Remarks

Please replace original drawing sheet containing figures 1 and 2 with the enclosed replacement drawing sheet.

Fig. 2

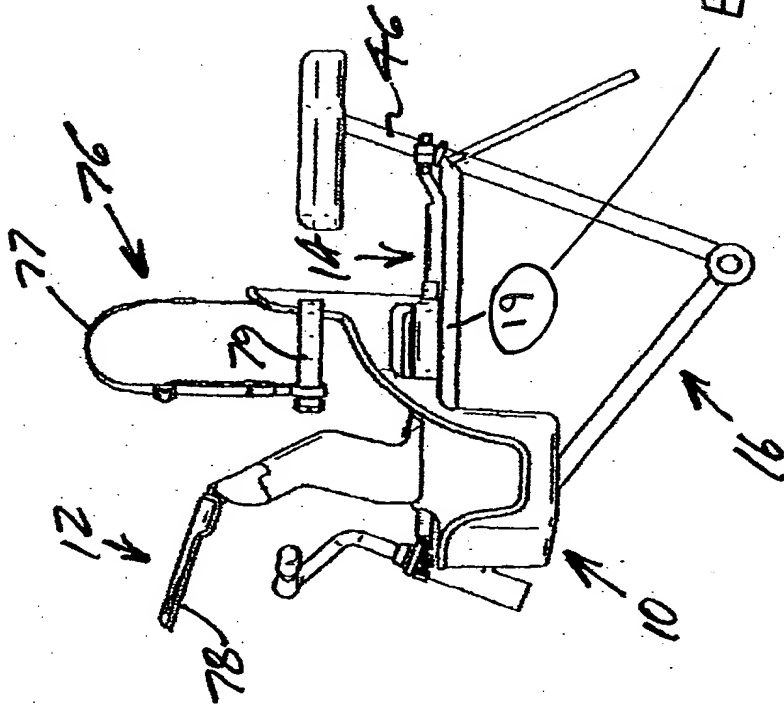
Figure 2 has been amended to add reference numeral 19 which identifies a top tube of a bicycle frame. It is notoriously well known that a top tube distinguishes a male-style bicycle frame from a female-style bicycle frame. Accordingly, no new subject matter is introduced

Element 19 added
